Re: Design Professional review IID – 18-05

RE: Response to Design Professional Review Comments
Julian Drew Lofts
IID-19-05

Julian Drew Lofts

LEVEL ONE
SCALE: 1/16" = 1'-0"

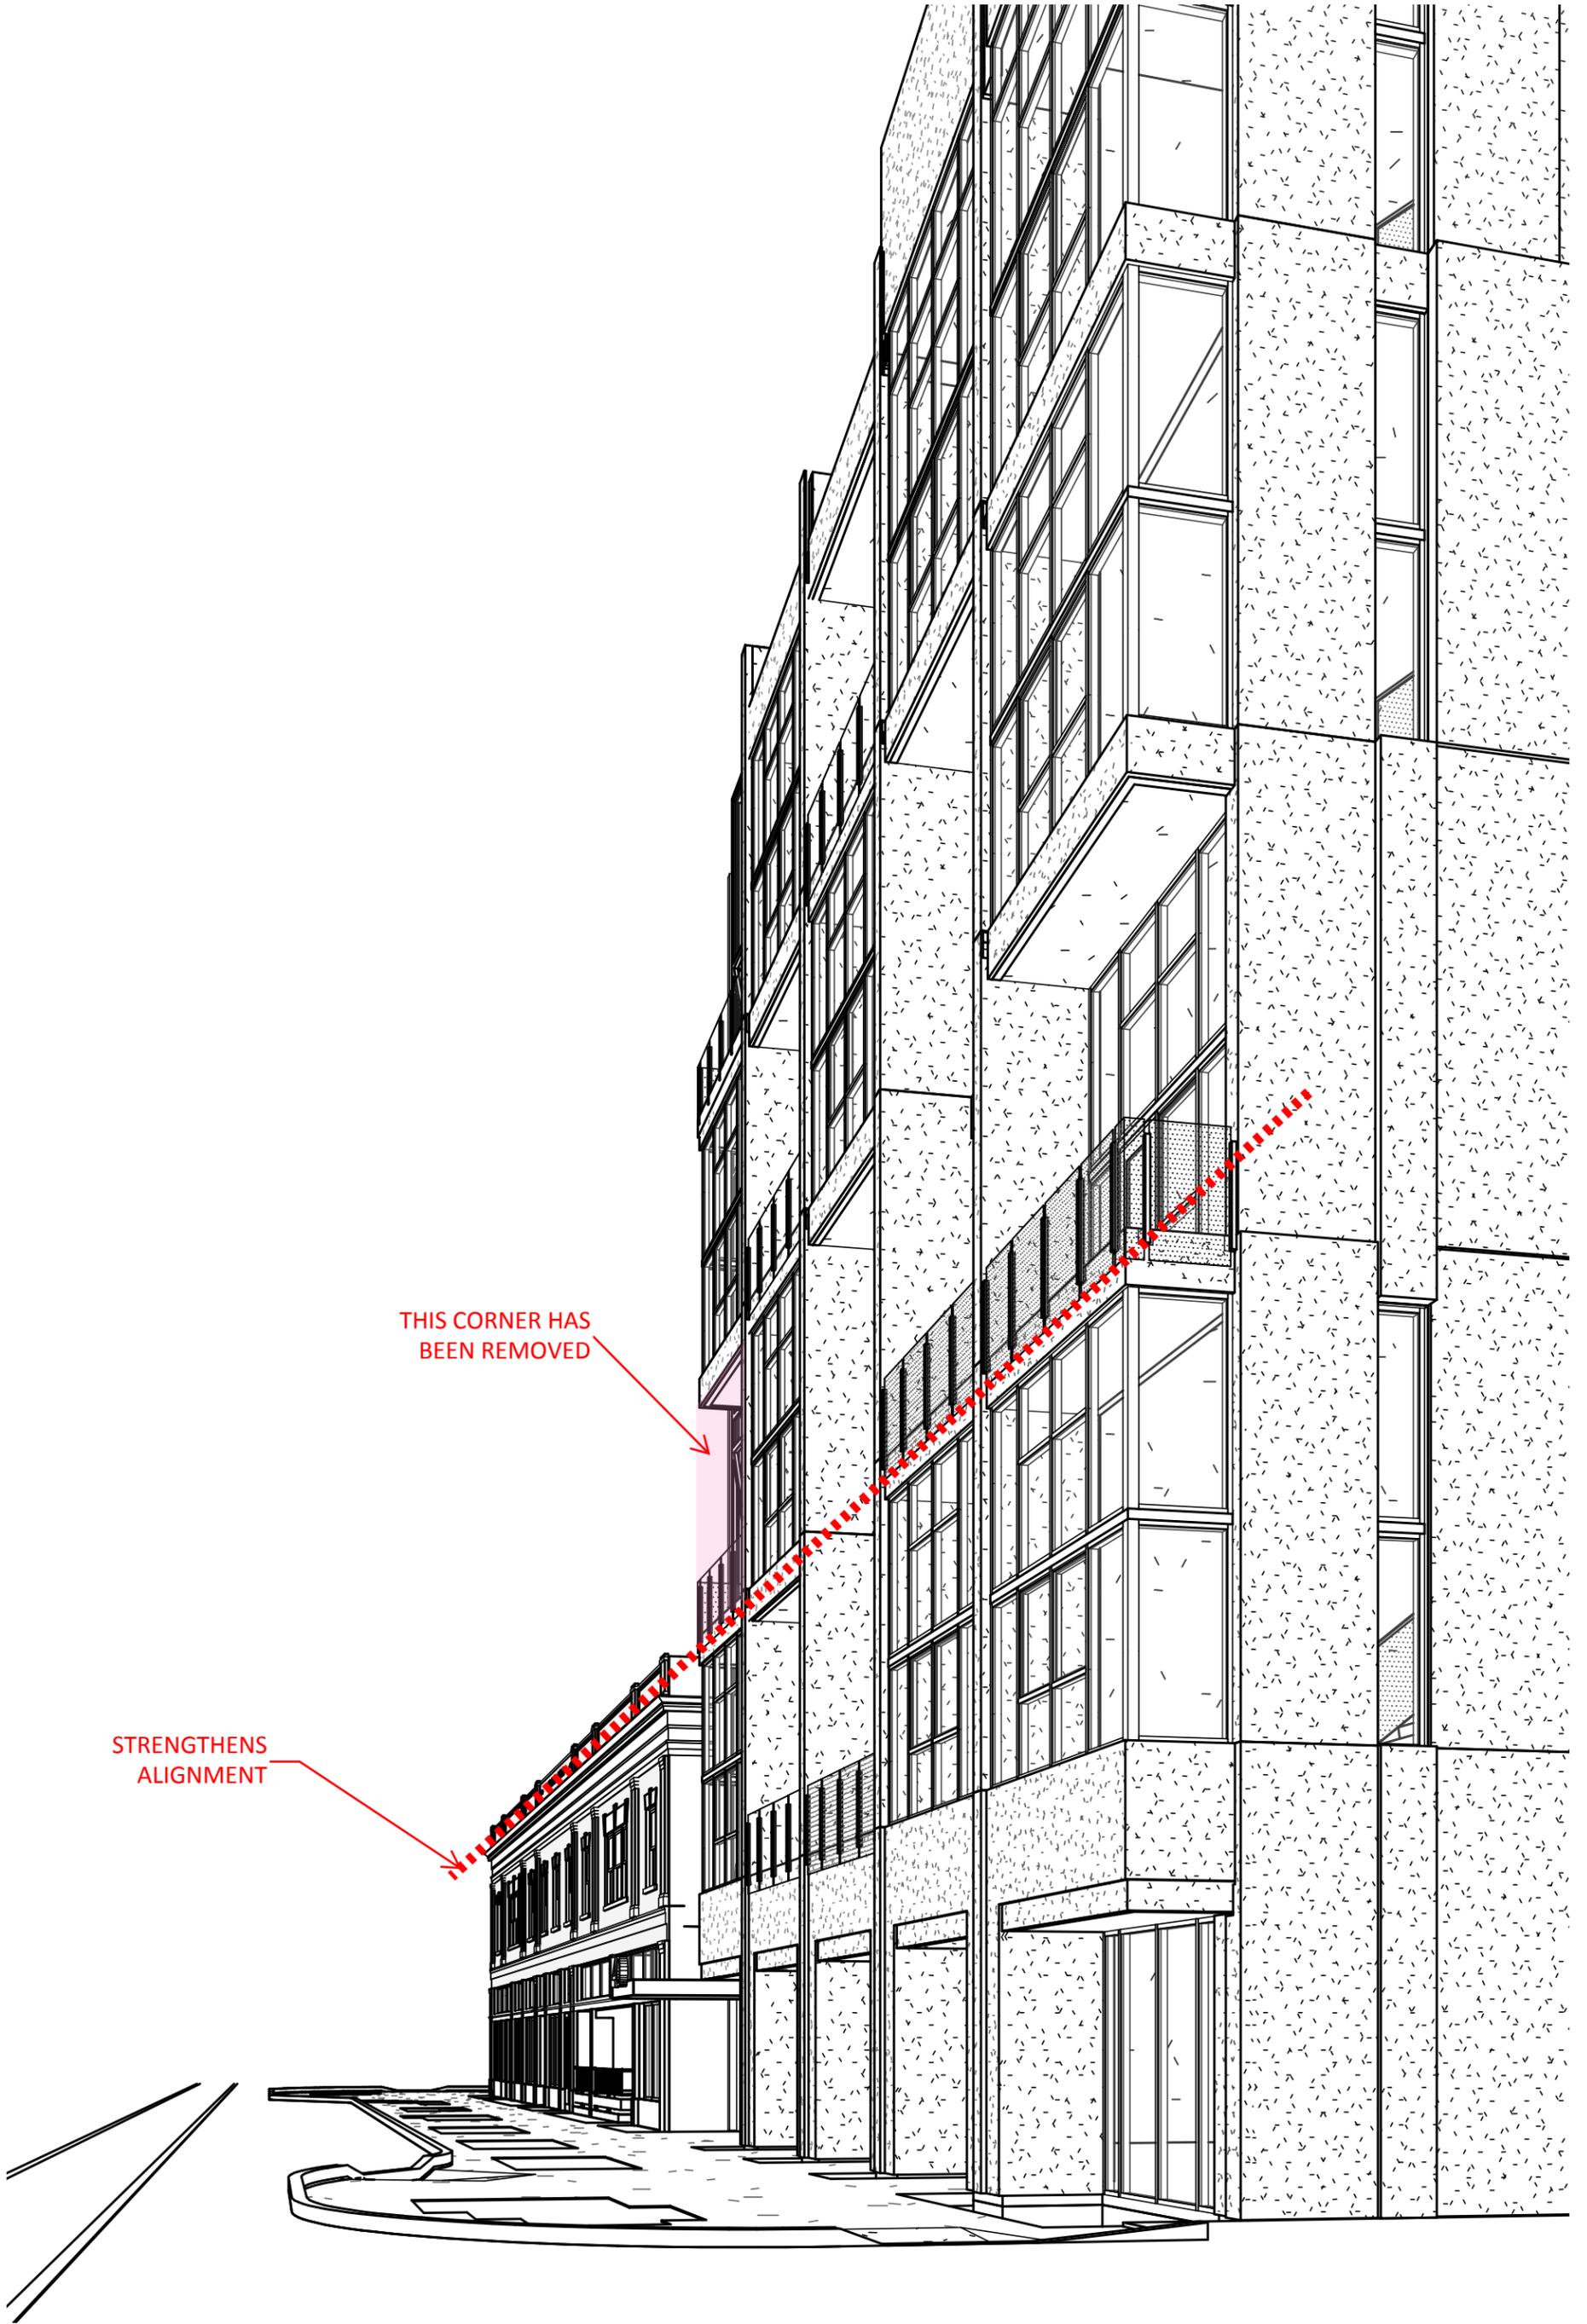
The addition of the sidewalk along the west should include a stripped cross-walk for safety along the south driveway.

Demonstrate provisions for adequate night lighting around the property and for security of pedestrians.

The suggested sidewalk is within the public R.O.W. Rick suggested that we show this in the Development Package for TDOT to review. Rather than striping, we discussed using a textured concrete to differentiate between the pedestrian walkway and the drive lane. (There is no vehicular traffic crossing this path at the south end of the site.) See the attached site plan for proposed sidewalk location.

The first level façade on all three primary elevations has a series of recesses. The exterior soffits above the recess will contain down-lighting adequate to provide safety for pedestrians. See the attached site plan.

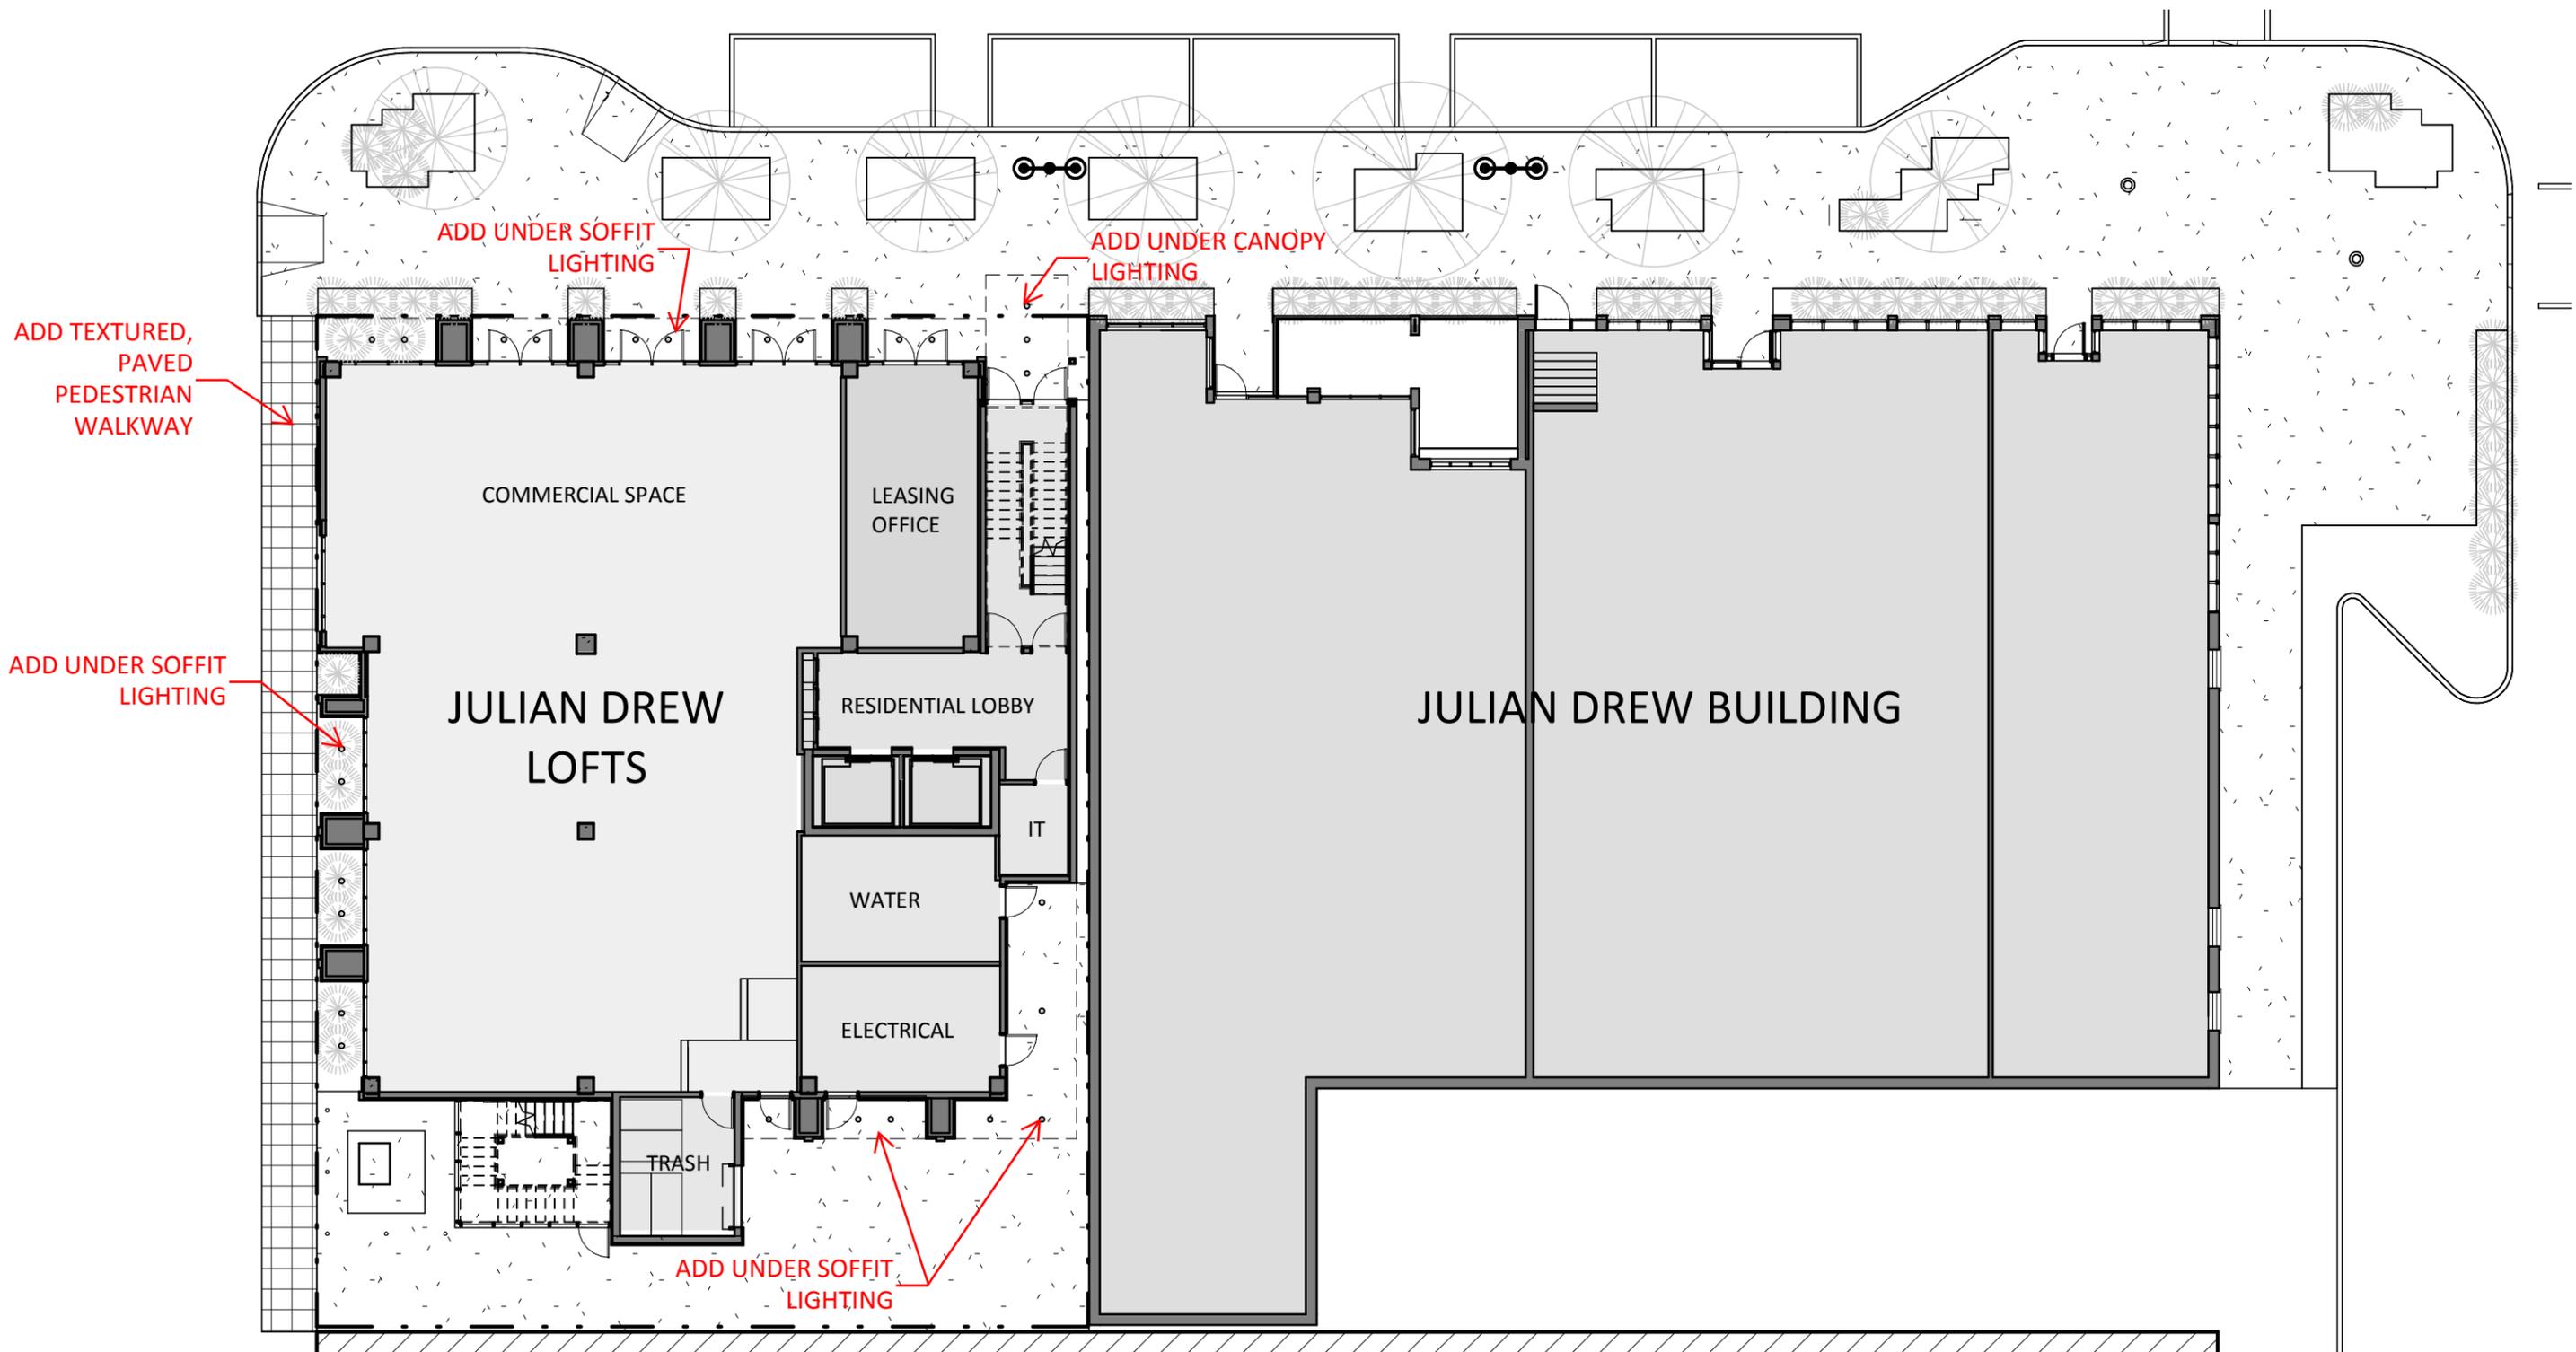
It is recommended that the design be enhanced with horizontal design elements above the 2nd floor that correspond better with the second level of the adjacent historic Lewis Hotel facade. The idea of changing the horizontal spandrel panels to be a color similar to that of the brick of the Julian Drew Building and Painted metals to be a darker, brownish-orange color should be considered.

In discussing the 3-dimensional imagery of Broadway Avenue provided both in the design submittal and additional sketches presented at this meeting, I explained that the northwest corner of the building is notched at the third floor which establishes a visual line corresponding with the parapet height of the existing Julian Drew building. It was suggested that a similar notch be created at the northeast corner to further emphasize this line. The attached drawings illustrate this modification to the submitted design.

THIS CORNER HAS BEEN REMOVED

STRENGTHENS ALIGNMENT
